ADDENDUM 4

FEBRUARY 20, 2024

**REEFER SERVICE AREA, PORT OF WILMINGTON
SCO#: 22-25839-01**

Questions received:

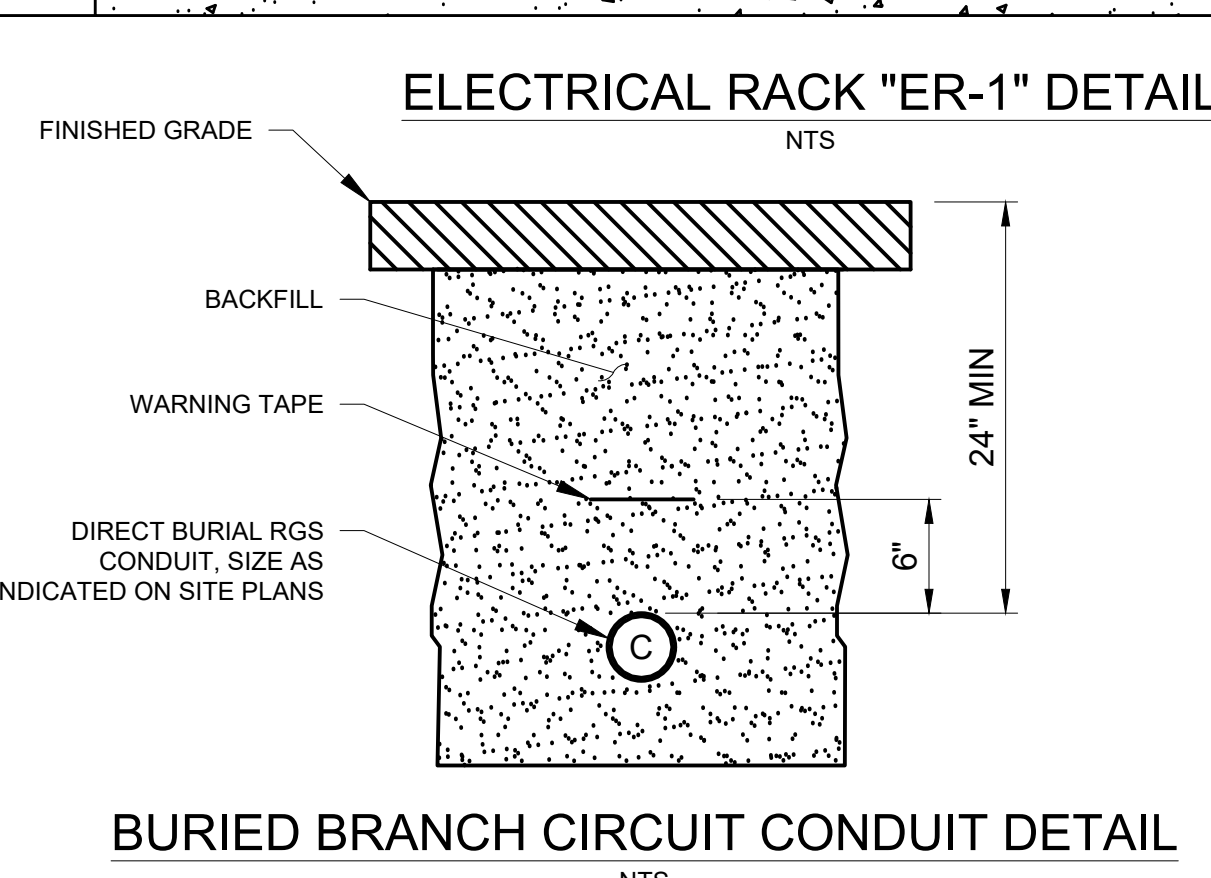
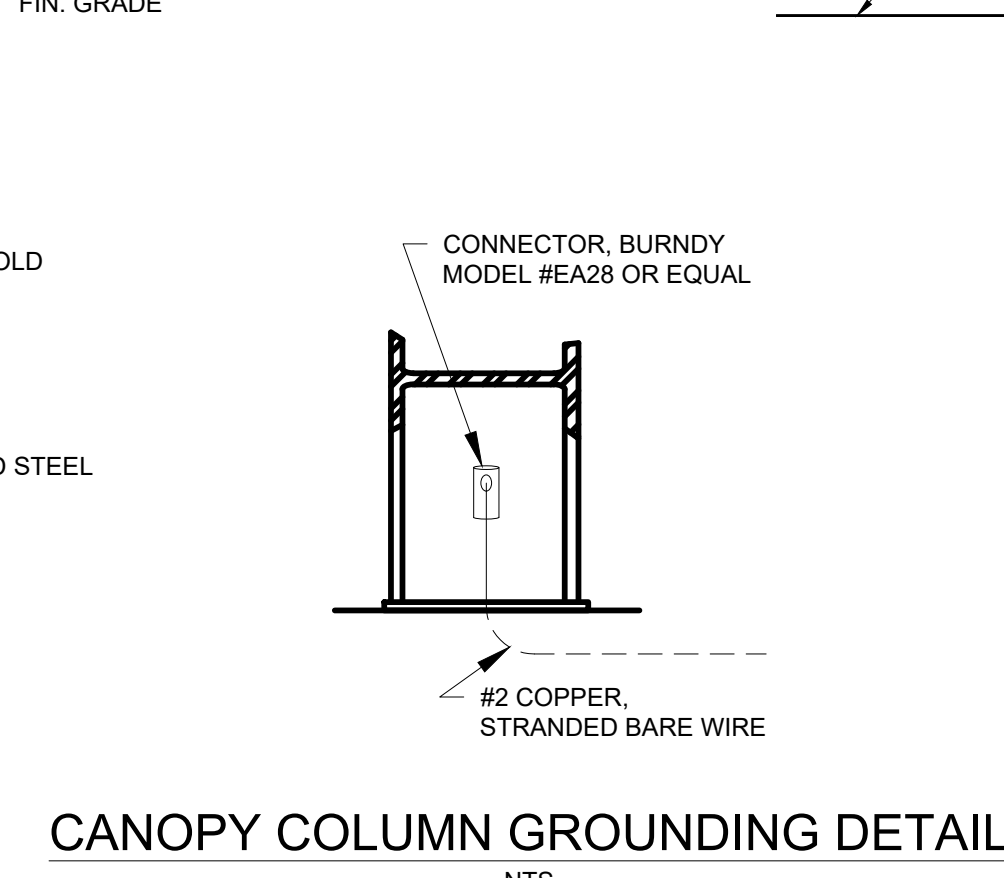
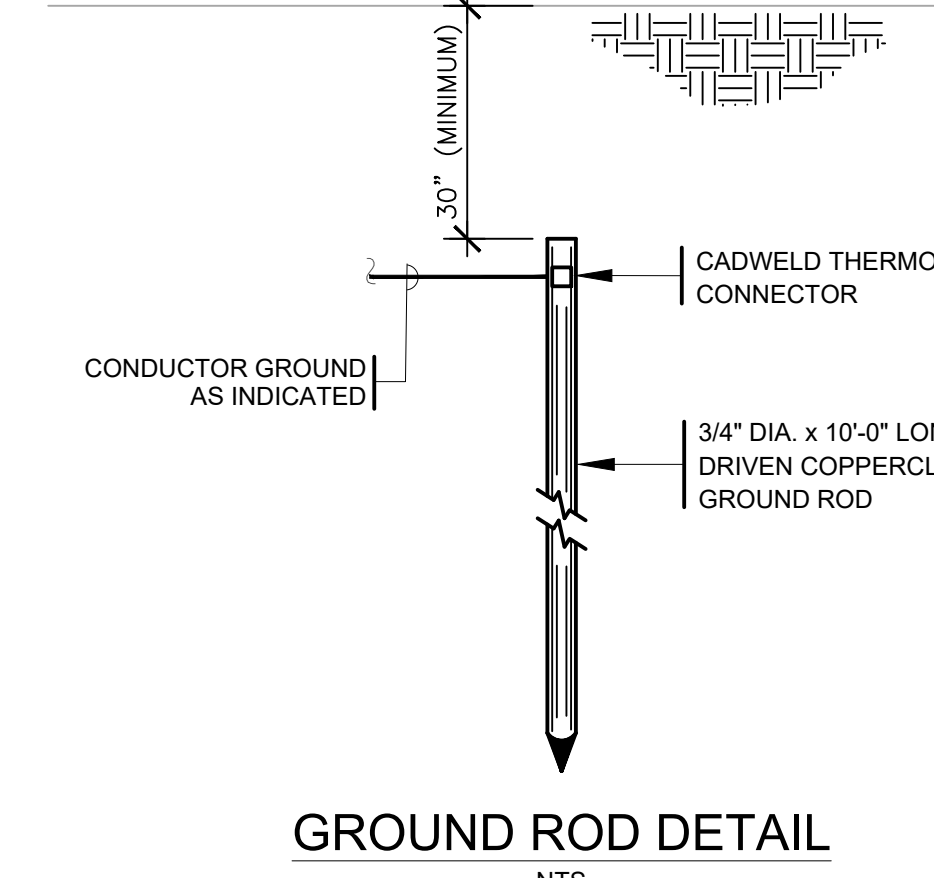
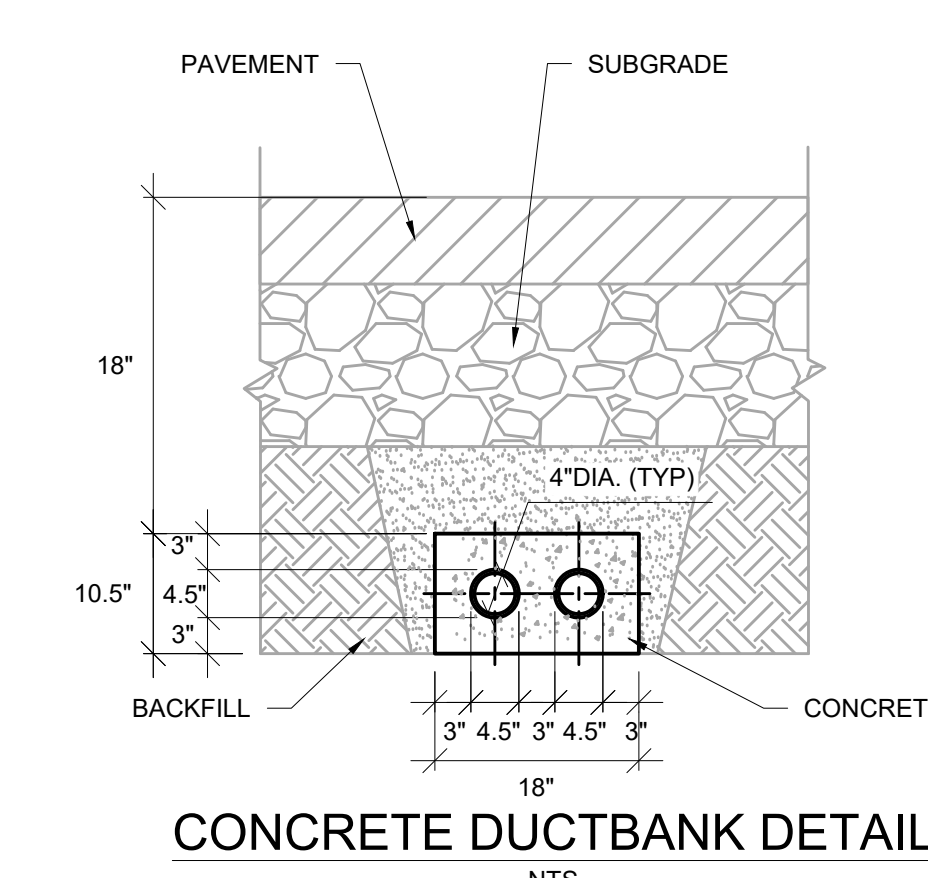
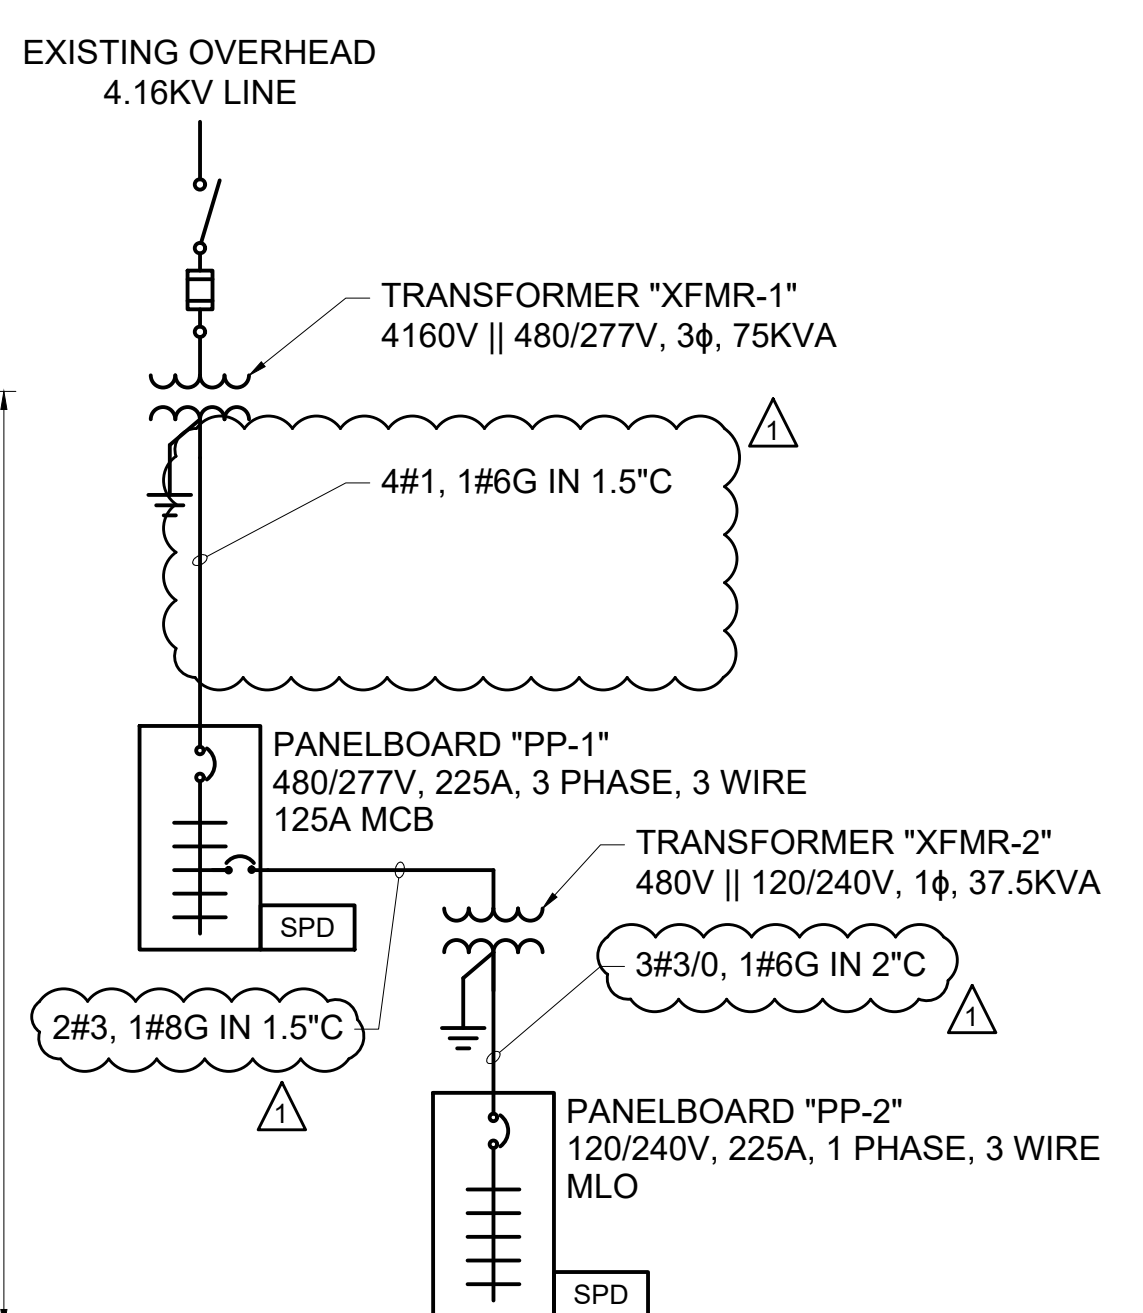
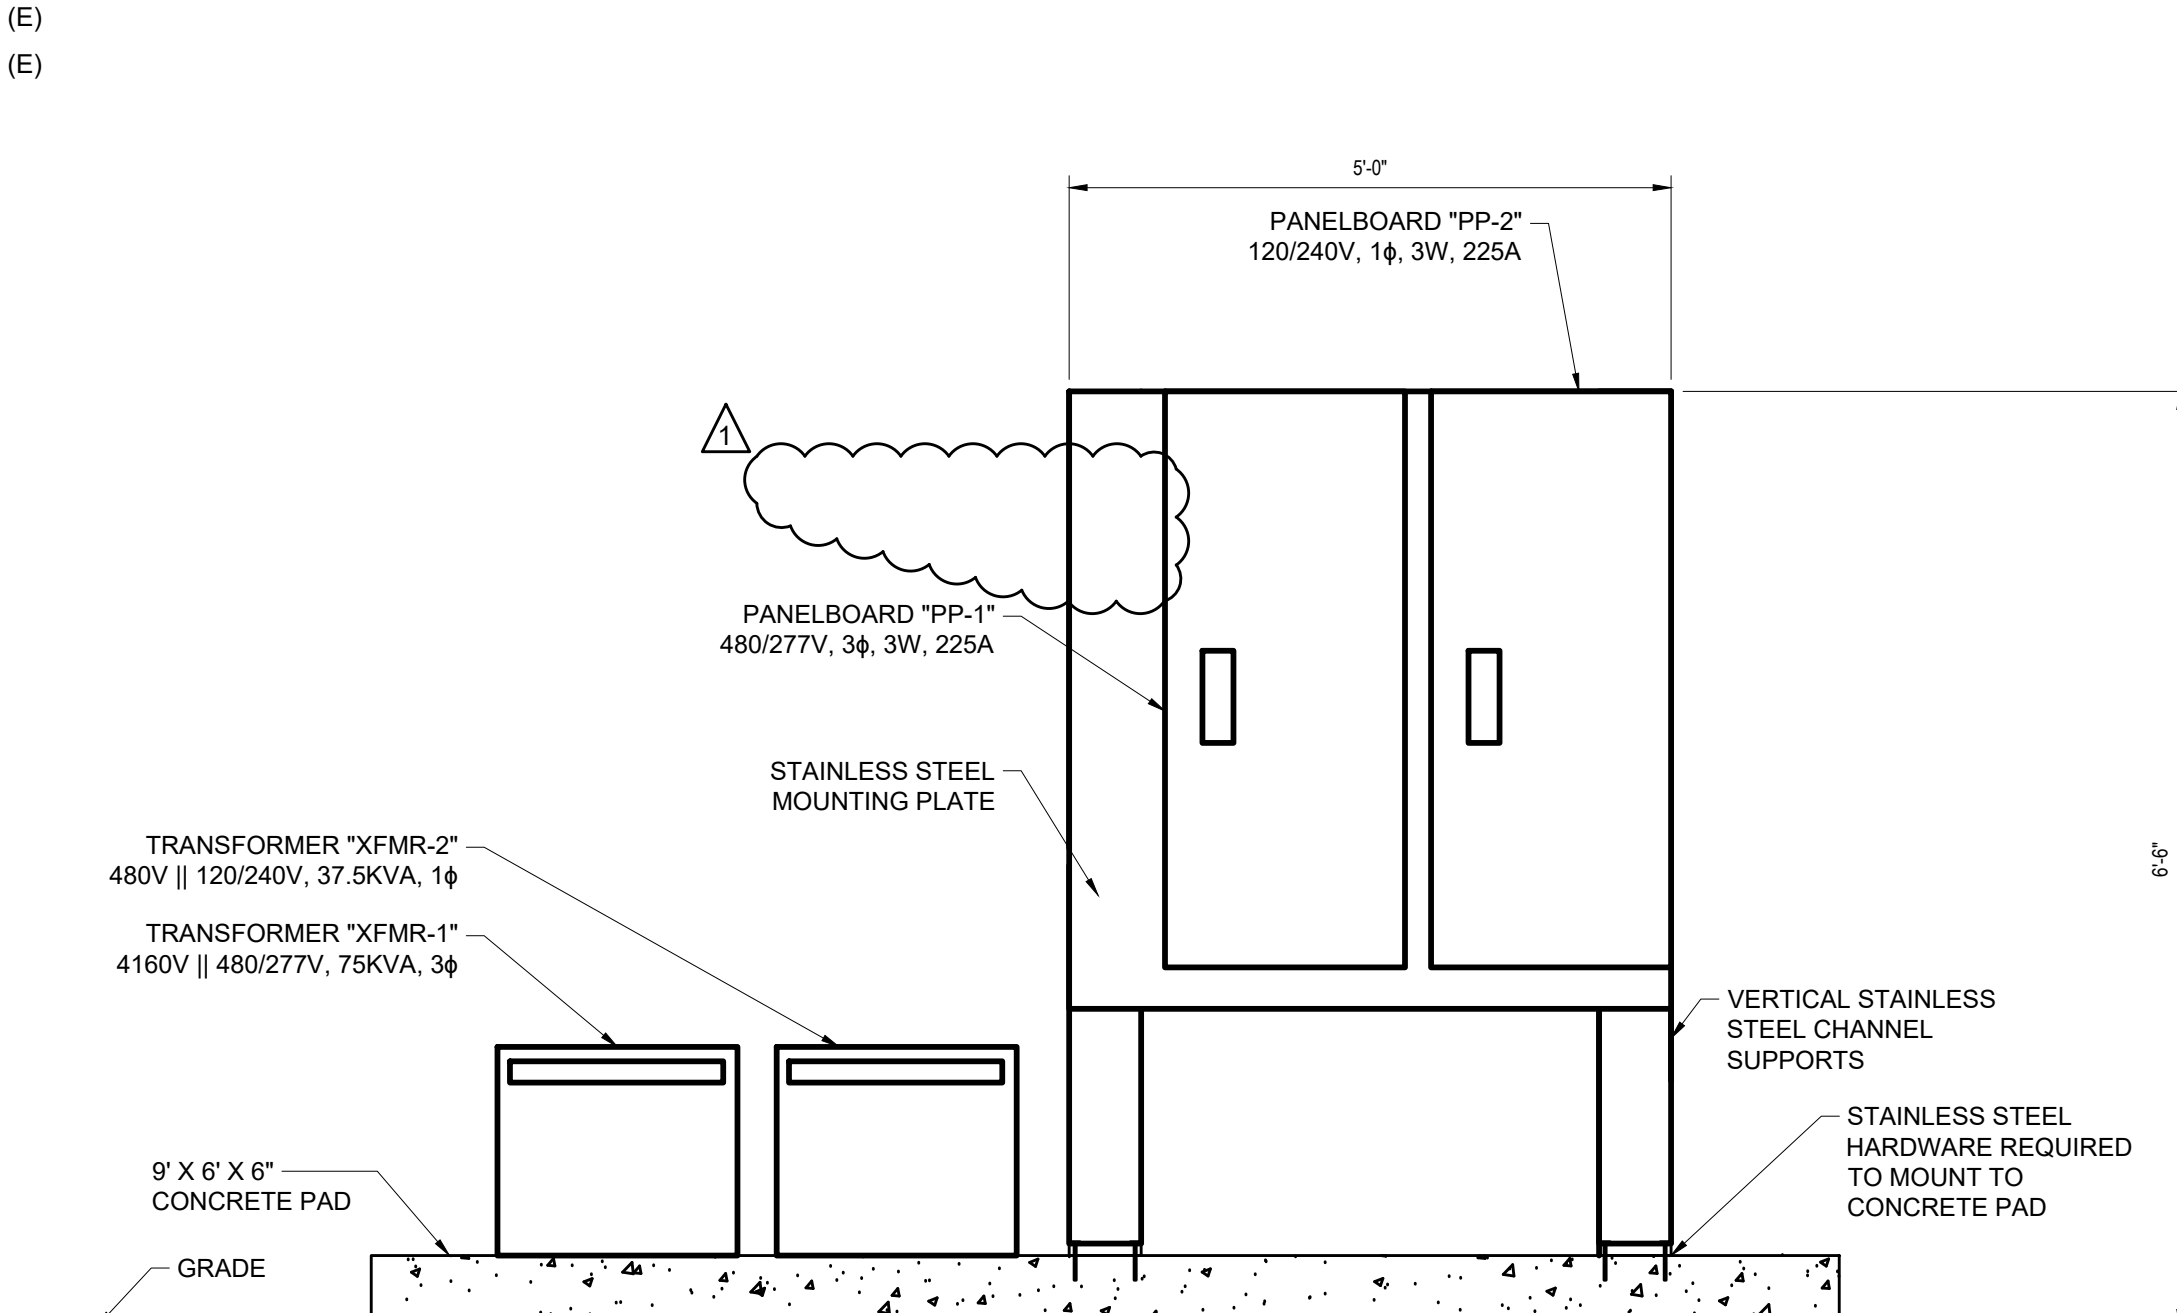
1. I can not find where there are associated conduit and wire sizing for the riser.
 - a. **Drawings will be revised.**
2. Why is there a meter drawn when the port owns the power that is feeding this structure. DUKE Energy will not be setting a meter for this application. If they are just wanting to monitor the electricity used, could they use some kind of alternate meter instead?

- a. **If the port owns this utility pole, a meter is not required. Drawings will be revised.**
3. Most all the equipment installed outside at the port is Nema 4X SS and the panels on the drawings are noted to be Nema Type 3R ... Should they be 4X?
